Access Compliance Report

Public Rights-of-Way

(Curb Ramps)

Intersection ID: 10033521	Main Street: OLD_PROVIDENCE_RD	Cross Street: N/A	Location: NE
ADA ID: BDE55E20E9B1	Ramp Type: PerpDiag	Initial Pass/Fail: Fail	Overall Compliance: No
		Severity Score: 25

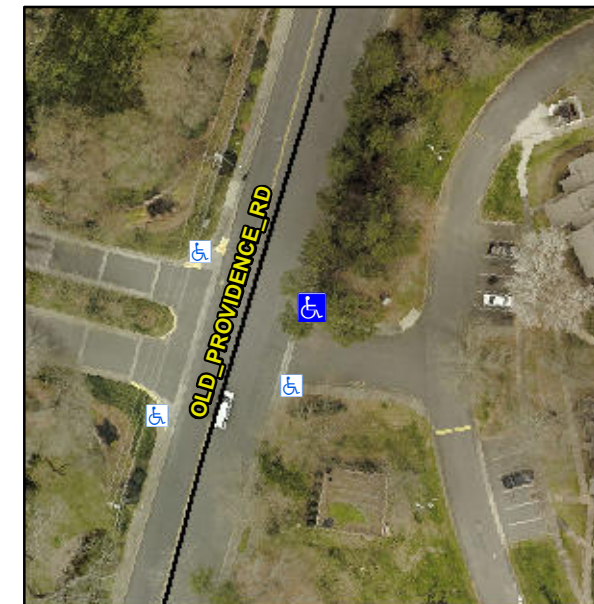
Not Found, R304.5.3

Compliance	Description	Data	Compliance	Description	Data
N/A	Ramp Length (in)	59.5	Yes	Ramp Slope (%)	4.5
Yes	Ramp Width (in)	48.0	No	Ramp XSlope (%)	13.5
N/A	Flare Type LT	N/A	N/A	Flare Type RT	N/A
N/A	Flare Slope LT (%)	N/A	N/A	Flare Slope RT (%)	N/A
N/A	Flare Traversable LT?	N/A	N/A	Flare Traversable RT?	N/A
N/A	Landing Length (in)	N/A	N/A	DWS Provided?	N/A
N/A	Landing Width (in)	N/A	N/A	DWS Contrast?	N/A
N/A	Landing Slope (%)	N/A	N/A	DWS Length (in)	N/A
N/A	Landing X Slope (%)	N/A	N/A	DWS Full Width?	N/A
N/A	Landing Curb? (Y/N)	N/A	N/A	DWS Offset (in)	N/A
N/A	Shared Landing?	N/A			
N/A	Gutter Ponding?	N/A	N/A	Gutter Slope (%)	N/A
N/A	Gutter Lip Ht (in)	N/A	N/A	Gutter X Slope (%)	N/A
N/A	Painted X Walk1?	No	N/A	Painted X Walk2?	No
	X Walk 1 Direction	To NW		X Walk 2 Direction	To SW
N/A	X Walk 1 Width (in)	N/A	N/A	X Walk 2 Width (in)	N/A
	X Walk 1 Slope (%)	4.7		X Walk 2 Slope (%)	1.0
	X Walk 1 X Slope (%)	0.9		X Walk 2 X Slope (%)	12.0

Remove & Replace Curb Ramp With Two New Directional Ramps or Equivalent.
